**PUBLIC INTEREST REVIEW FOR GROUND WATER APPLICATIONS**

TO: Water Rights Section Date 21 December 2015  
 FROM: Ground Water/Hydrology Section K. Lite  
Reviewer's Name  
 SUBJECT: Application G- 18142 Supersedes review of \_\_\_\_\_  
Date of Review(s)

**A. GENERAL INFORMATION:** Applicant's Name John Giorgi County: Crook

17.00S/23.00E-12DD  
CRO0 53416

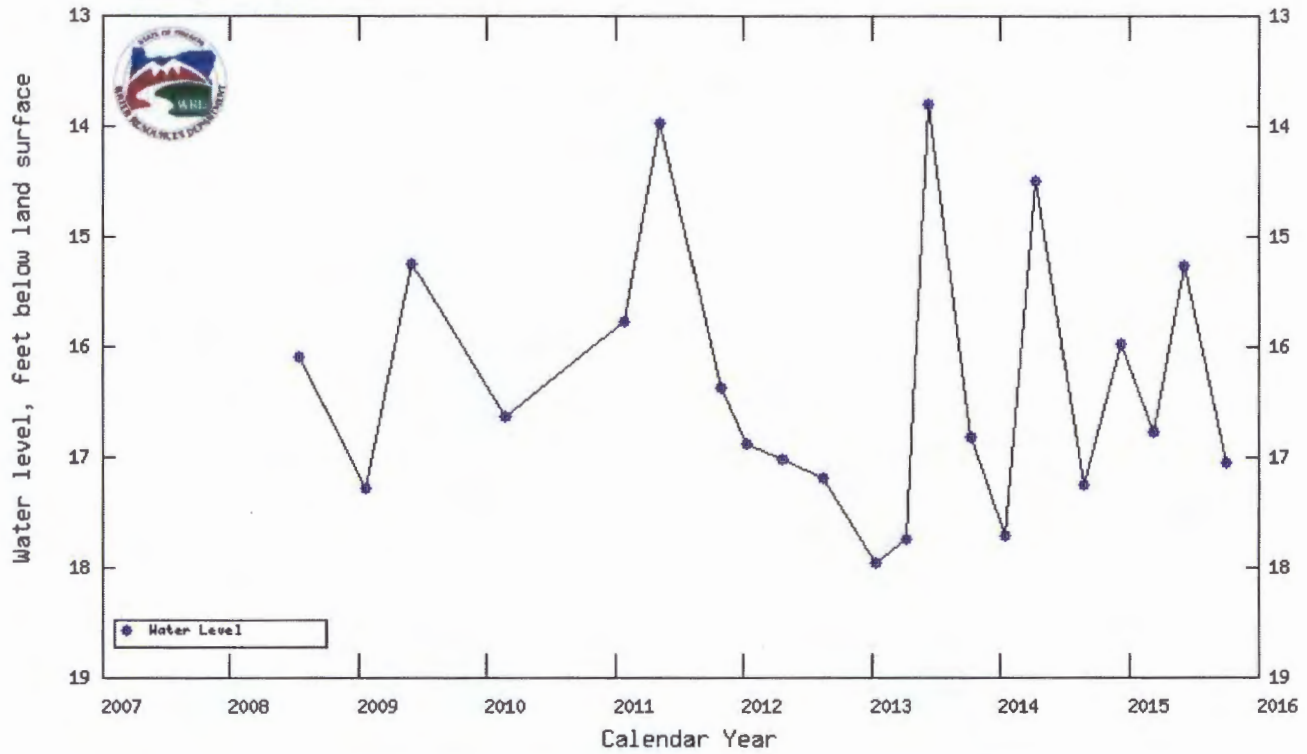
**A large amount of groundwater has been, and is being permitted in a relatively small area in the vicinity of this well. The sustainability of the resource in the area, given the new development, is unknown. The groundwater resource is likely relatively small (in area) within the Paulina Basin. There are several observation wells in the general vicinity of the new development. Wells located relatively near surface water show no decline, whereas the wells located greater than a mile show some decline.**

**Condition with 7B and 7N**
